Template for comments and secretariat observations

Date:2010-03-16

Document: prEN 15221-6

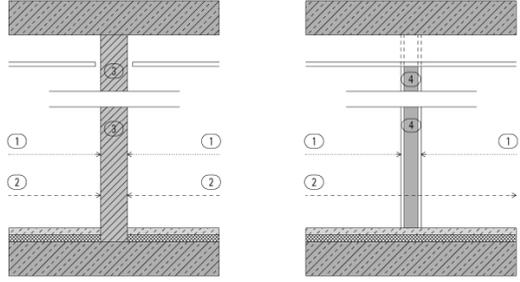
103					using the example NFA	
CH 104	5.1	tab. 1		Categories of areas – hierarchy of floor areas	Hierarchy of categories of floor areas (?)	
DE 105	5.1	Note A, B, C	ed	Please substitute "spaces" with "areas"	A Areas which... B Areas which... C Areas which...	
DE 106	5.1	Note C	ed	Please delete the word "entirely"	C Areas which are not covered , but...	
DE 107	5.1	Table 1, and the whole document	ed	Please substitute "Total Level Area" with "Level Area"		
DE 108	5.1	Table 1	ed	Please substitute "Rentable Floor Area" with "Floor Area"		
UK 109	5.1	Table 1	NEW	Figure claims that Rentable Floor Area = Net Floor Area, but the line says Rentable Floor Area = Net Room Area	Need to correct line to Rentable Floor Area = Net Floor Area	
UK	5.1	Paragraph 5	NEW	The application of the framework given in table 1 is	Insert clause 5
